project	Arlo Dairy Site, Victoria Road South Ruislip	drawn by	GJ
status	For Planning	checked by	IG
title	Planting Plan Plaza	date	09.01.14
Xref	xref	scale	1:250 @A1
drawing No	1061-201	revision	P

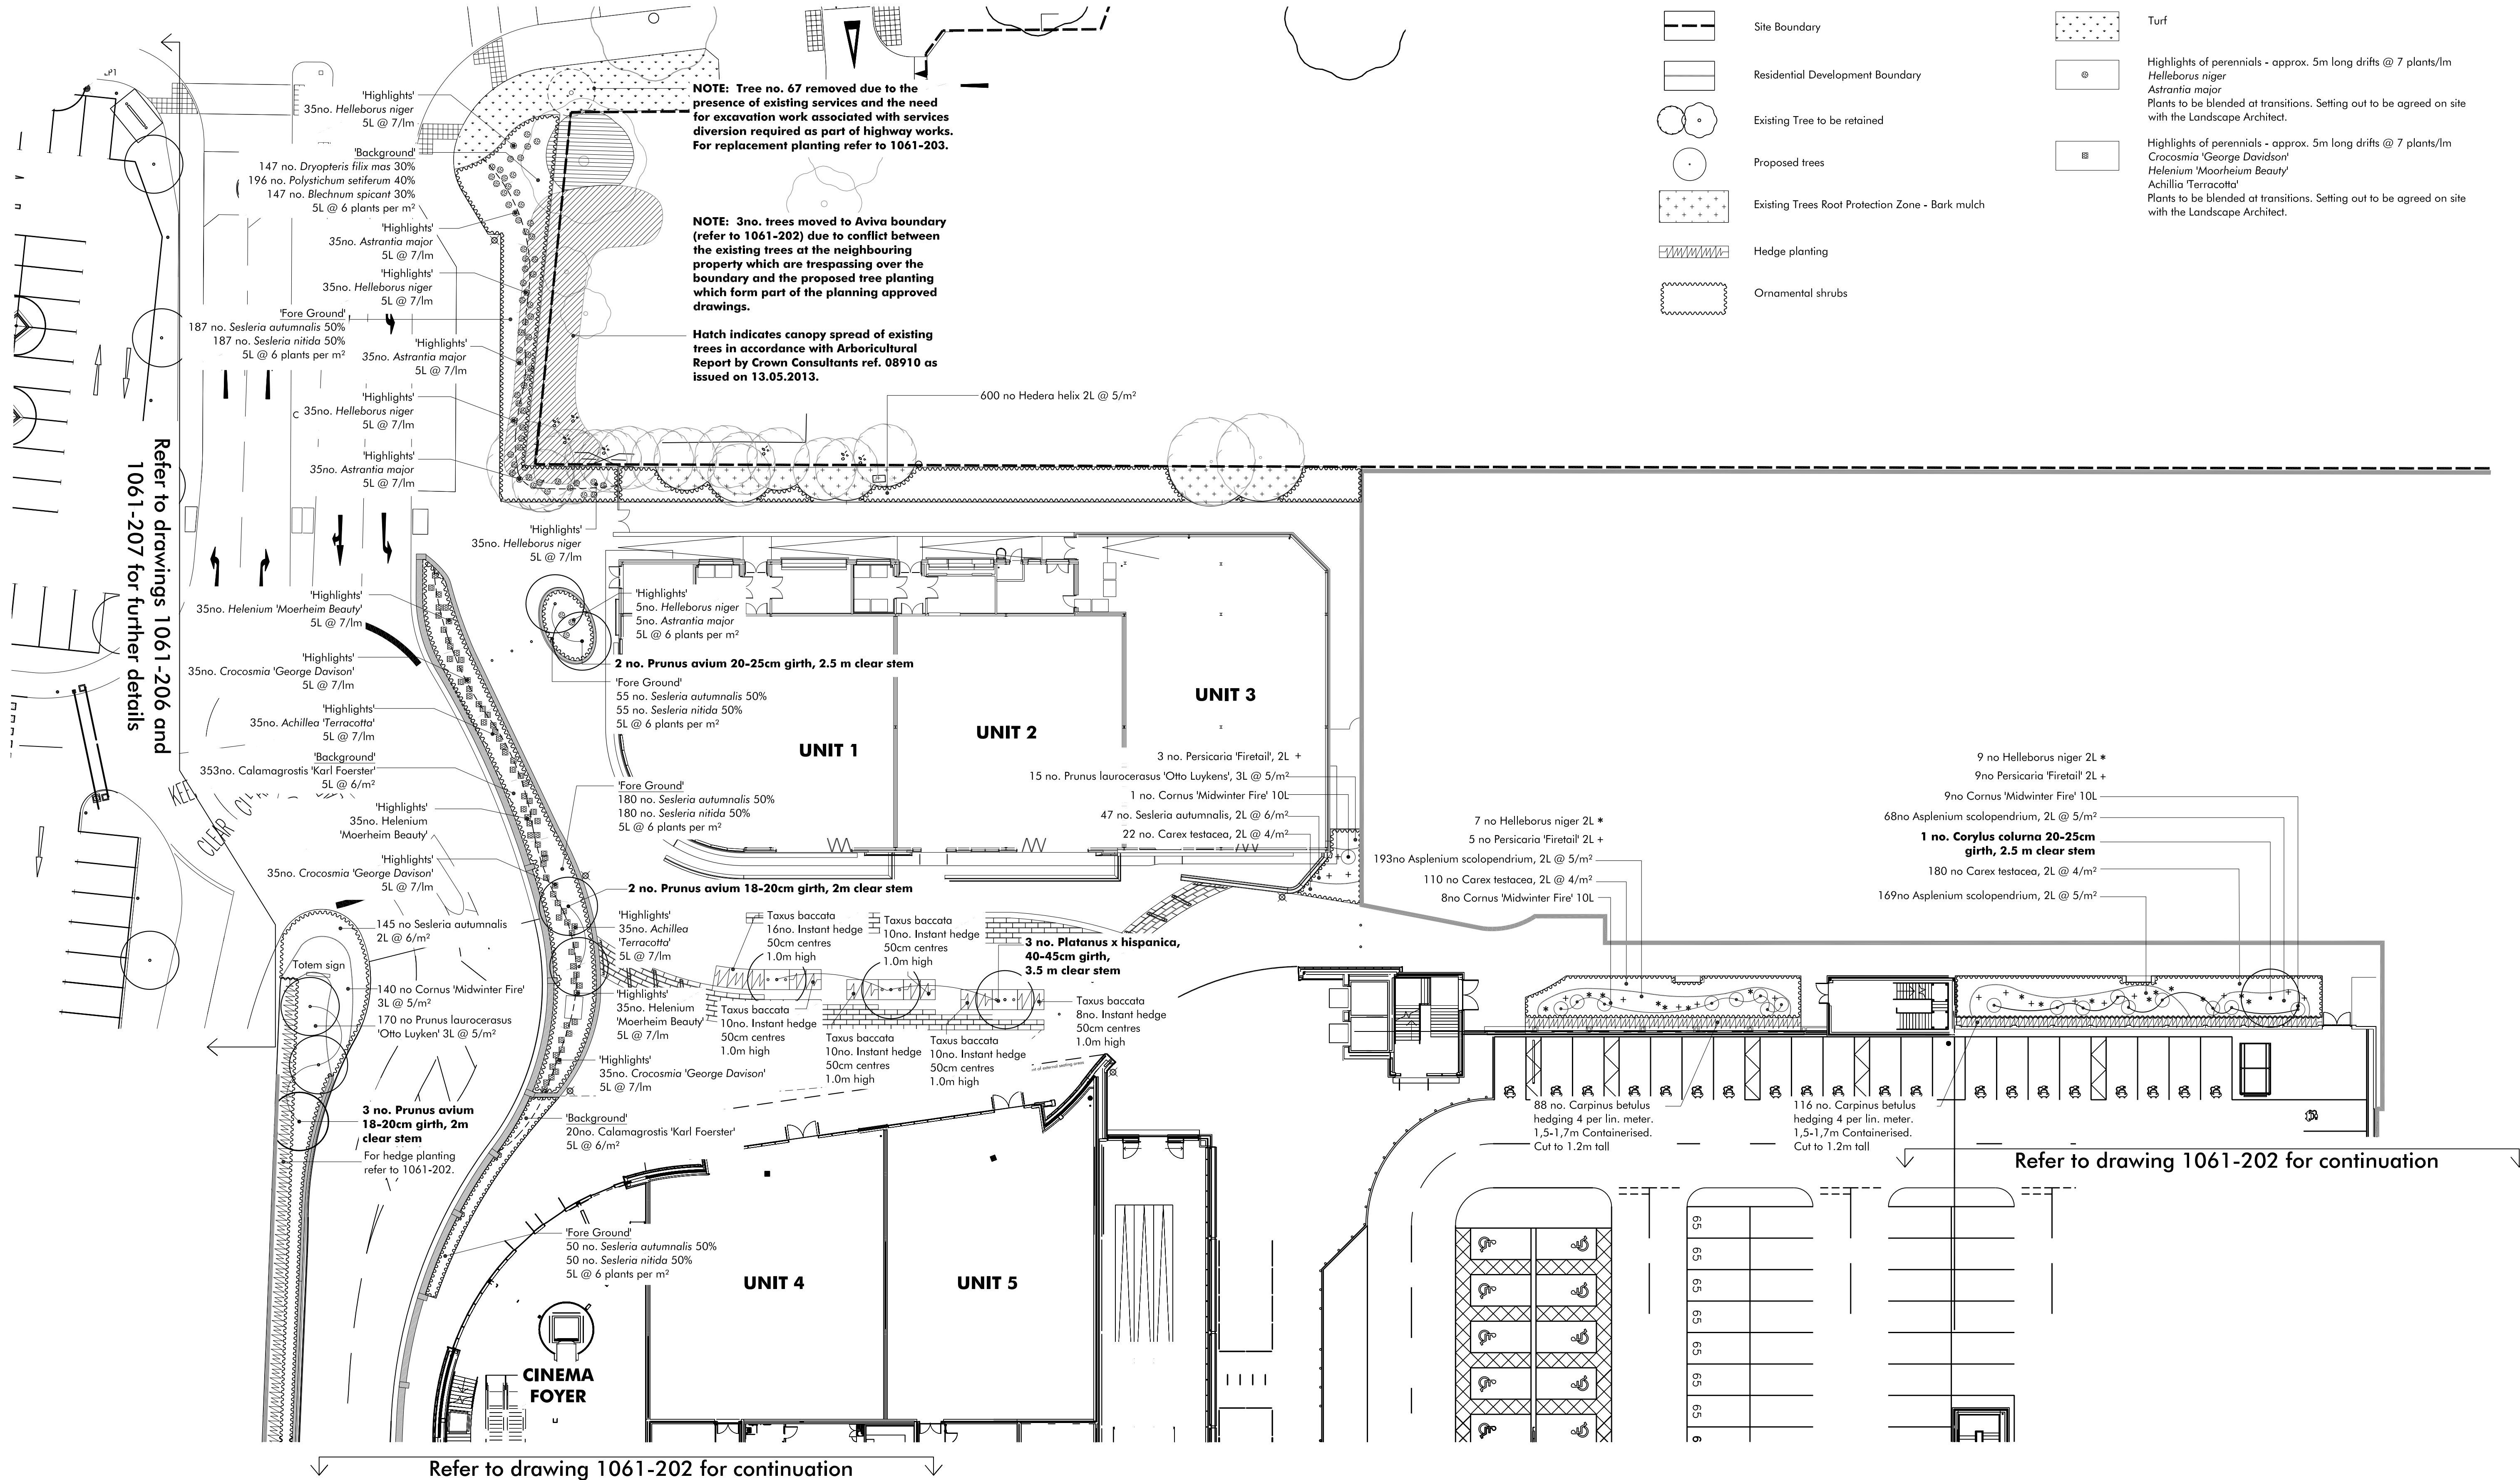
-	Issued for Comment	AS	GJ	10.06.2014	G	Issued for client review. Amendments to planting at main entrance.	KN	RG	13.06.2016	L	Record Issue for O&M Manuals	KS	RG	28.10.2016
A	Minor amendments. Issued for Draft Tender	AS	GJ	30.06.2014						M	Record Issue for O&M Manuals	IN	RG	02.12.2016
B	Issued for Planning	AS	GJ	10.07.2014	H	Issued for planning. Removed tree at entrance replaced as shown in 1061-203.	KN	GG	24.06.2016	N	Record Issue for O&M Manuals	IN	RG	09.12.2016
C	Issued for Contract	WH	GJ	01.12.2014	I	Issued for planning. Planting amended along main entrance route. Hedges added.	BM	RG	26.07.2016	O	Record Issue for O&M Manuals	IN	RG	21.12.2016
D	Issued for Contract	GJ	MS	27.04.2015	J	Issued for construction. Changes to hedge layout by roundabout. NO change in numbers.	KN	RG	23.08.2016	P	Issued for Planning. Adjustment to location of Totem Sign.	RM	JC	13.02.2017
E	Construction	AP	KN	24.03.2016

F	Issued for client review. 3no. trees at entrance moved to Aviva boundary. General update of shrubs and perennials in accordance with plant availability.	KN	RG	09.06.2016	K	Issued for Planning-Condition 7. Replacement of tree planting and adjustments to tree positions	KS	RG	25.10.2016
